VLBA ACQUISITION MEMO #258

11 July 1991

Subject: Write Driver Asymmetry Improvements

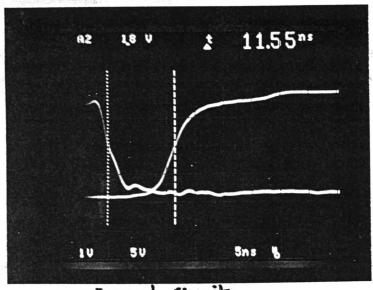
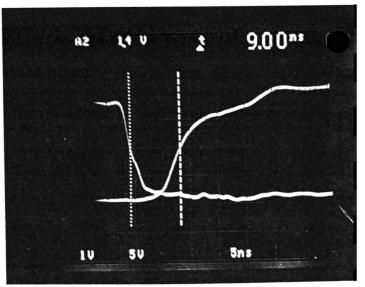
4] Replacing the MCLTI-6T (RF Transformer) with the circuit as below:

Figure 1B

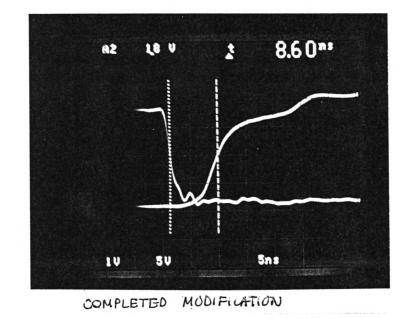
1] Change input coupling to DS0026 from 0.1 μ f to 47 pf in parallel with 1K Ω . This reduces the asymmetry from 11.6 to 9.0 ns. (see Figure 1B)

Figure 1C

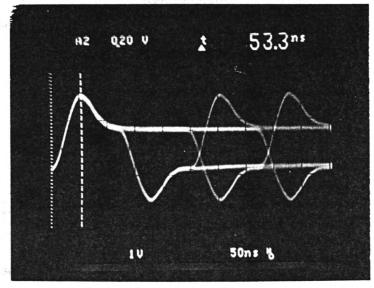
2] Replace 74AS822 with 74F822. Since about 2 ns of the asymmetry arises in the reclocking flip-flops replacing them with fast logic further reduces the asymmetry from 9.0 to 8.6 ns. (see Figure 1C)

Present Circuit Output

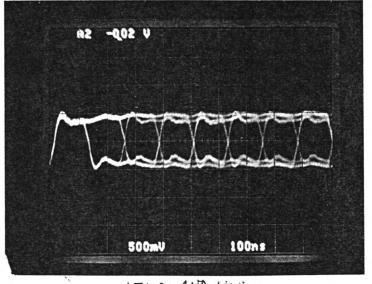
3] Replacing the 100 Ω resistor in series with the output with a 33 Ω makes a further improvement in both symmetry and rise time.
